AND IN THE MATTER OF an application by McLean's
Mountain Wind LP for an Order granting leave to construct a
new transmission line and associated facilities.

**MCLEAN'S MOUNTAIN WIND LIMITED PARTNERSHIP
RESPONSES TO MCSEA, LSARC, BAYNICHE CONSERVANCY,
WIKWEMIKONG ELDERS, COMMUNITY AND YOUTH, AND
MANITOULIN NATURE CLUB INTERROGATORIES**

DELIVERED MARCH 30, 2012

GANTT CHART REVISED MARCH 29, 2012

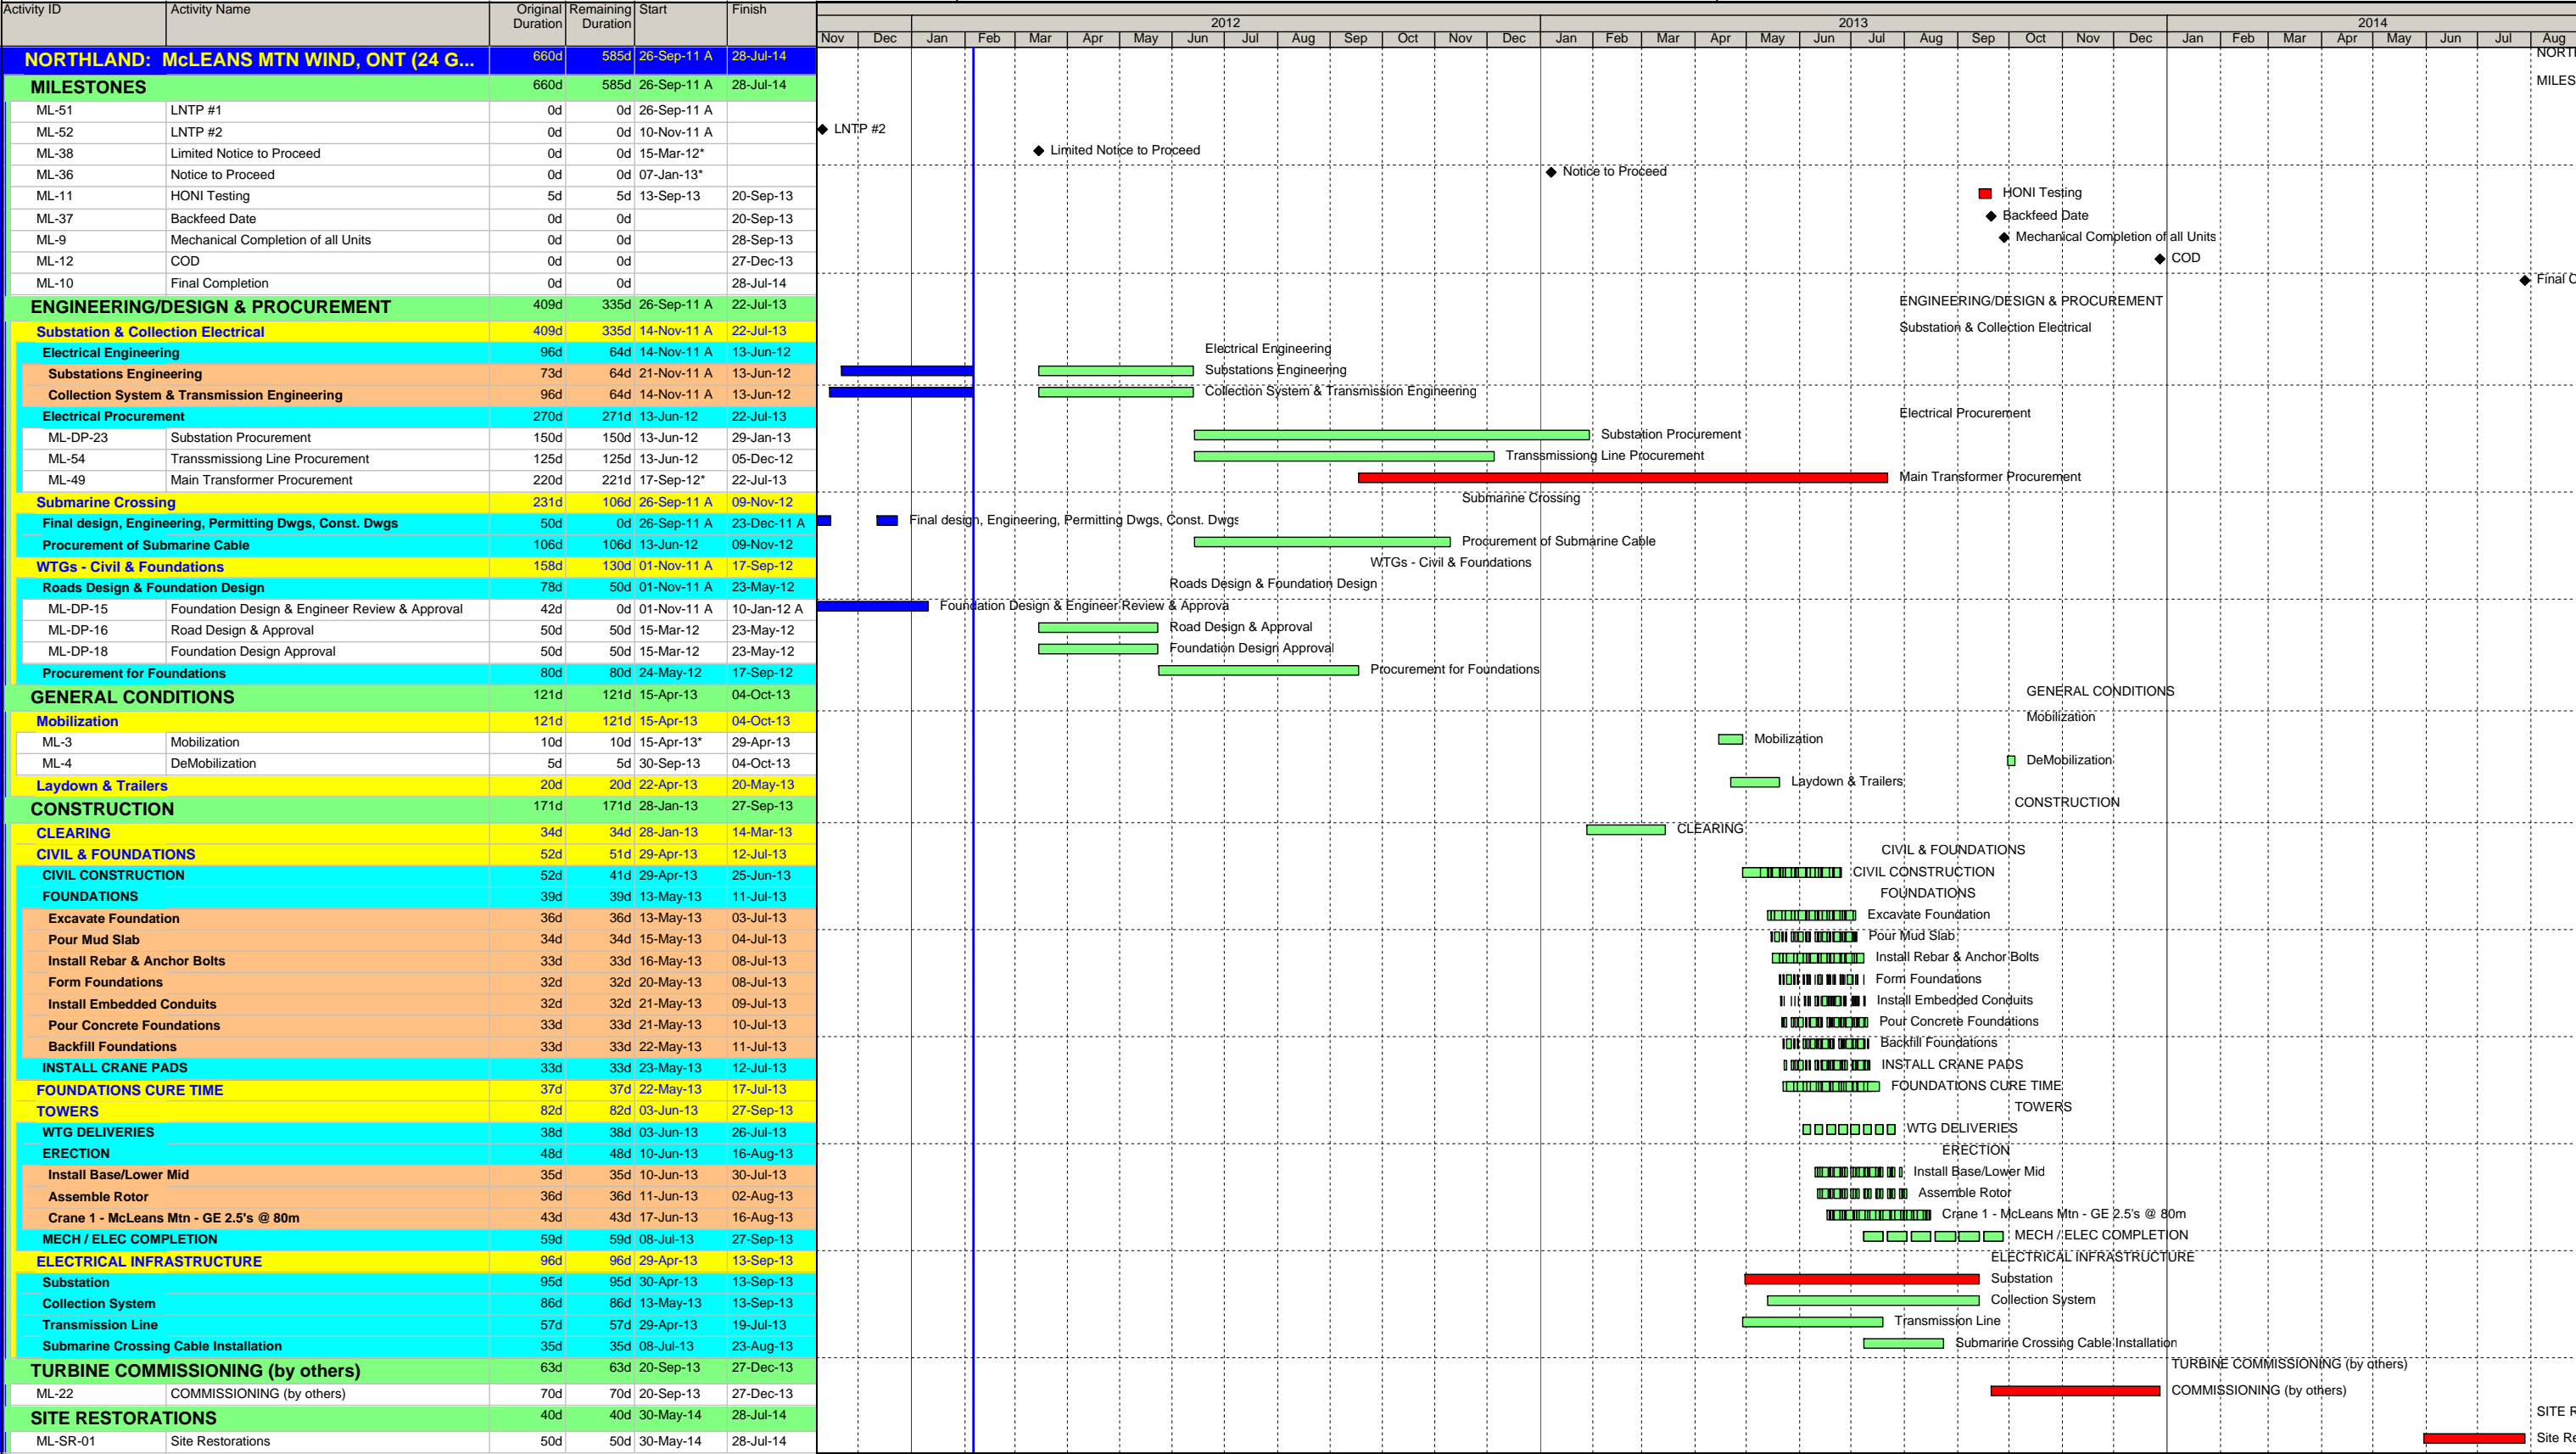
Please provide a detailed breakdown of proposed construction schedule in Exhibit F.

Reference Exhibit C Tab 4 Schedule 1: This reference states that the site work is to begin in the Winter 2011. How is this evidence consistent with the applicant only filing its case with the Board in November 2011? Please provide updated dates. Please update the GNATT chart provided in C/T4/S2.

Please see the modified Gantt Chart in Attachment 1 to these responses.

Please see the Applicant's response to Question 60, above.
